**Subject:** Submission Details for

**SSD 6011 - Mixed use residential development within the South West Plot**

## Summary

LEVEL 7

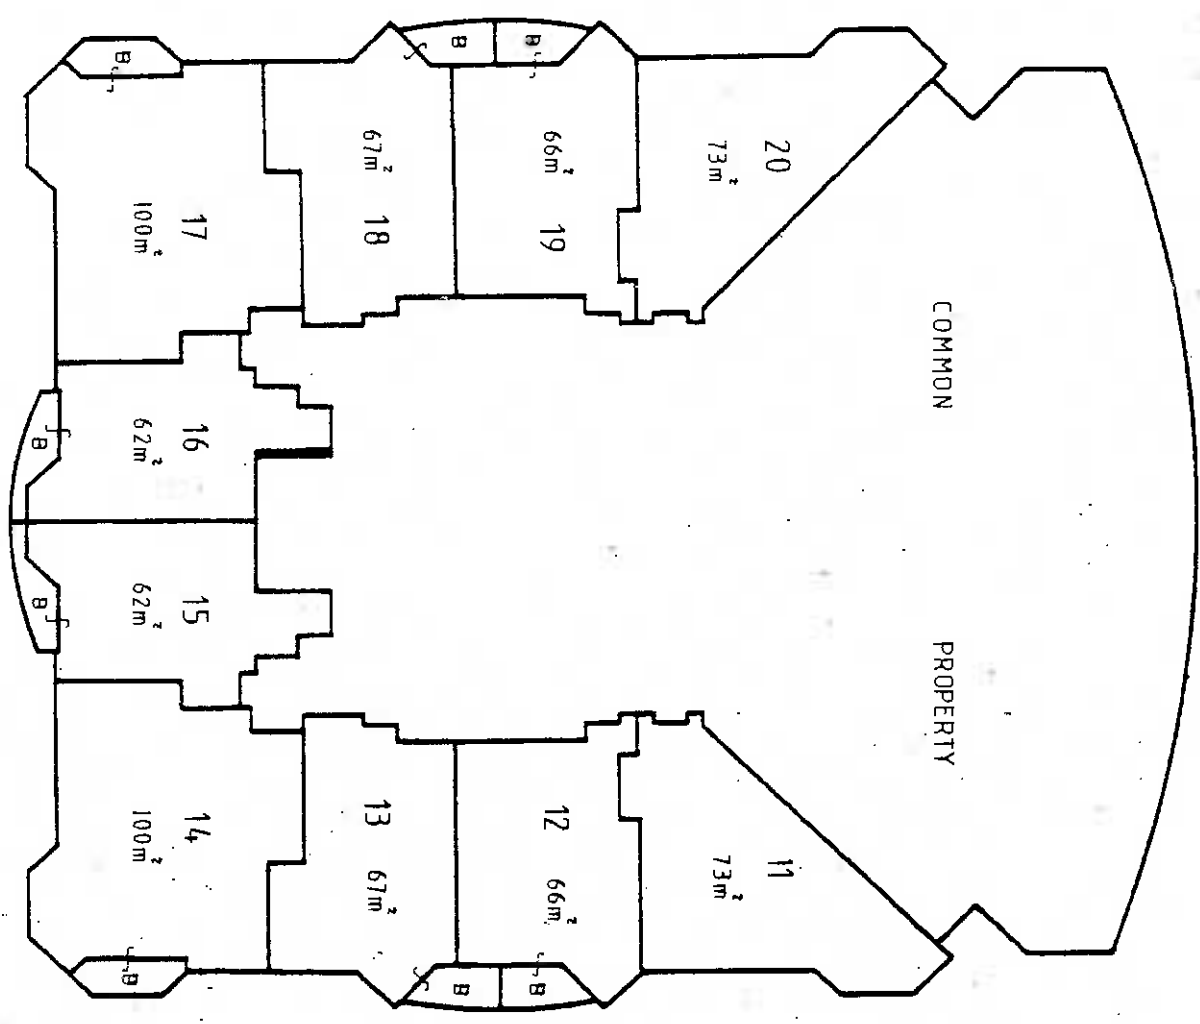
Levels 6 and 7 each contain two apartments with single west aspect , i.e. 4 single aspect apartments.

LEVEL 8

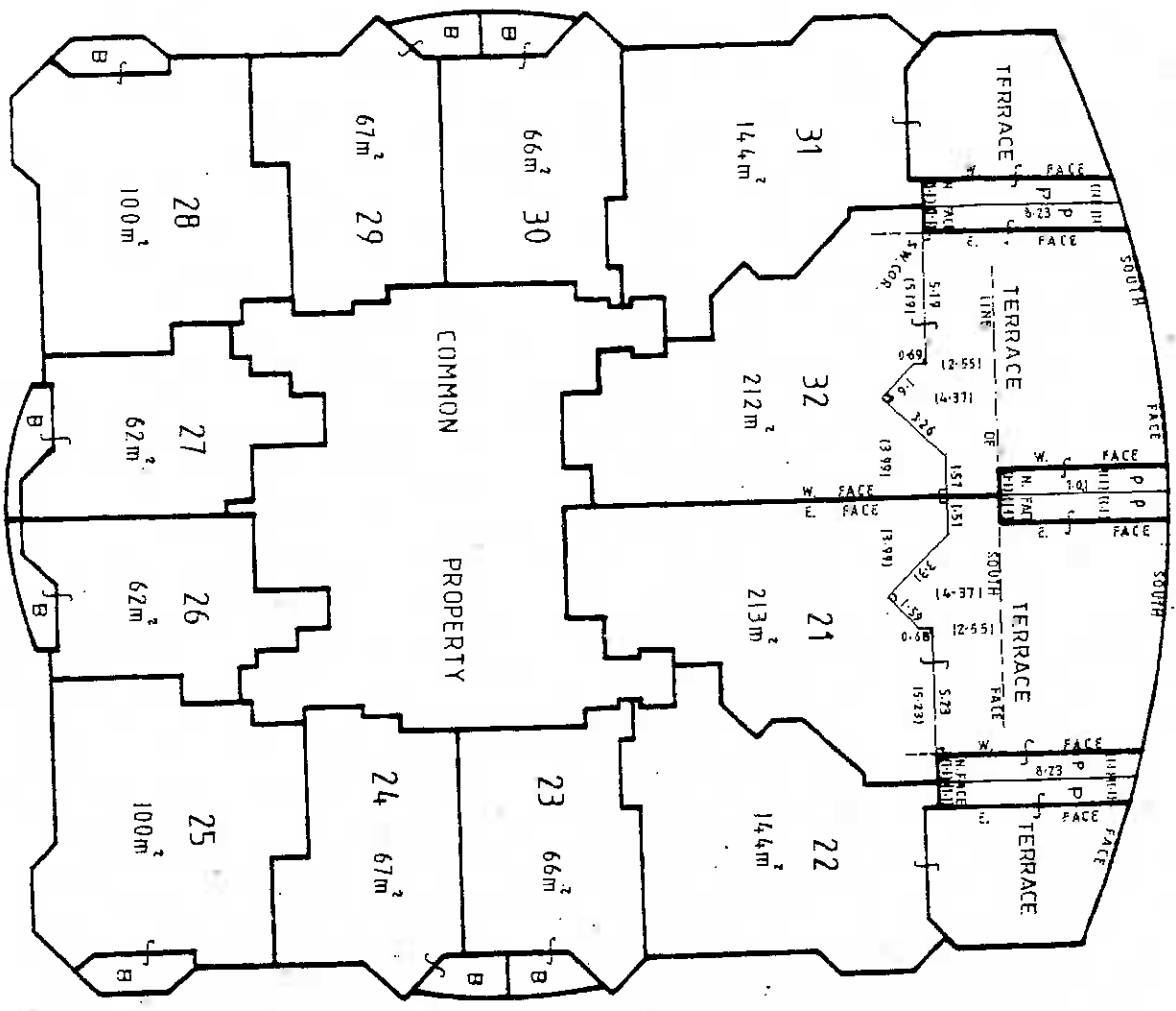
Levels 8-15 each contain two apartments with single west aspect and two apartments with single north aspect , i.e. 4 single aspect apartments per level, giving 32 single aspect apartments.
